NVM Express Technical Errata

Errata ID	009
Change Date	4/21/2011
Affected Spec Ver.	NVM Express 1.0
Corrected Spec Ver.

Replace Figure 135 with the figure below, updating step 5 (indicates most recent SQ entry fetched):

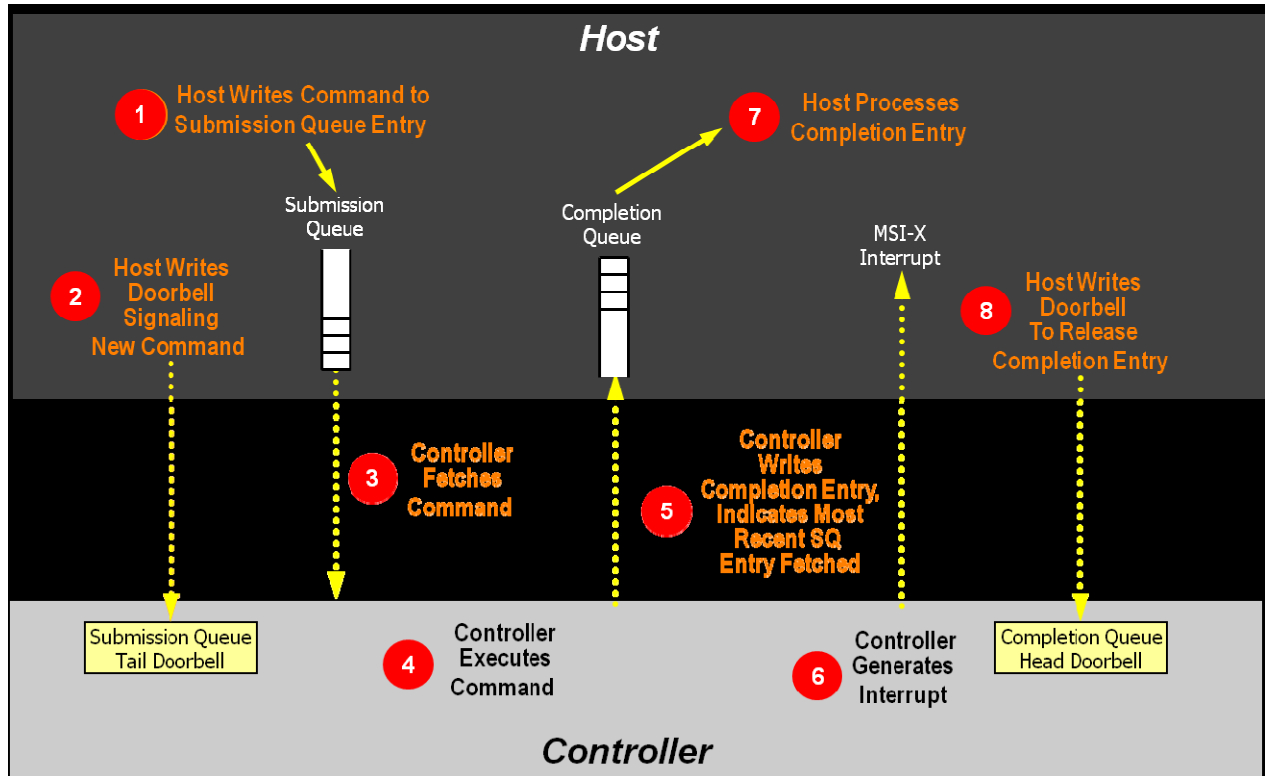
Modify step 5 of section 7.2.1 as shown below:

5. After the command has completed execution, the controller writes a completion entry to the associated Completion Queue. As part of the completion entry, the controller indicates **the most recent SQ entry that has been fetched** ~~that the associated Submission Queue entry is free for the host to re-use as part of communicating the latest Submission Queue Head value to the host.~~
